**Campaign for the Protection of Rural
Wales
Brecon and Radnor Branch
Upper Noyadd, Clyro, HR3 5JS
01497 820814**

HENDY WIND FARM: Land Off A44 SW Of Llandegley Llandrindod Wells Powys

Application for discharge of condition 31 from P/2014/0672 (APP/T6850/A/17/3176128): Engineering drawings for construction traffic access to site

CONDITION 31: Engineering drawings for construction traffic access to site

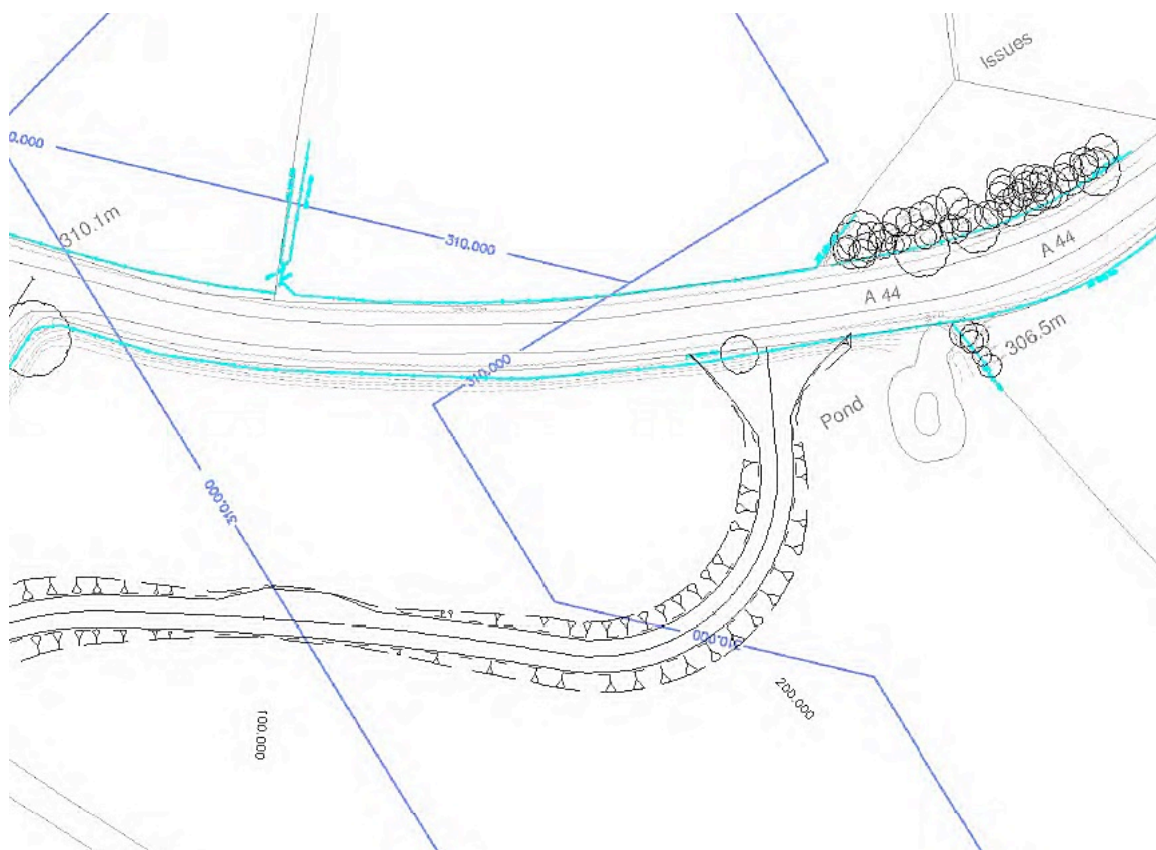
N access – permissions required and land title: In support of the application to discharge this condition, the developer has submitted drawings setting out an entirely new piece of development which lies **outside the site red line** of approved plans for which the Minister has given consent. This new development requires both planning permission from the local authority, and, as ‘restricted works’ on a registered common will also require Commons Act consent from the Planning Inspectorate. PCC Highways have stipulated that a bituminous macadam surface for a minimum of the first 15m back from the road edge is required – this is also ‘restricted works’. The developer must also be required to demonstrate that he has the correct certificates in place to support an application for permission for works on this land, title of a major part of which has not been proved to be held by Sir Robert Green-Price. This is a point on which the Council would be well advised to take urgent legal advice.

The plans do not describe what will happen to the trees. At the N corner of the N entrance there is a venerable scots pine which is said to be a drovers landmark associated with the Drovers Inn Grade II listed building at Larch Grove. This together with the traffic, hydrology and amenity issues at Larch Grove have not received proper attention. On the south side there is a copse of trees all along the road towards the signpost to the bridleway across the common. We have pointed out in our previous objection that the developer’s statement in submission for Condition 27 that the works at the N access are temporary and reversible is clearly untrue. The land in question is wet, undulating and rises to the west. It also contains a drainage ditch/stream and a copse on the roadside. This area, roughly 30m north-south along the A44 south of the gate, and extending approximately 60m along the track, is to be levelled, culverted, a new ditch created around it, and the entire area put down to hard standing. The wetland copse on the roadside will be felled. There is obviously no way that the works can be reversed and the site returned to its present state. There are no responses from NRW, Powys Built Heritage or Powys Ecology in relation to these matters.

There is already frequently a problem with flooding on this stretch of the A44, opposite Larch Grove Grade II listed building, and it is clearly essential that for the amenity of the neighbouring house and the safety of road users the suitability of any drainage plans proposed must be verified, and implications of culverting and felling for flooding issues on the A44 fully considered.

Powys Development Management should by now be aware of the level of public outrage which any failure to enforce against unlawful works on the Llandegley Rhos common will attract.
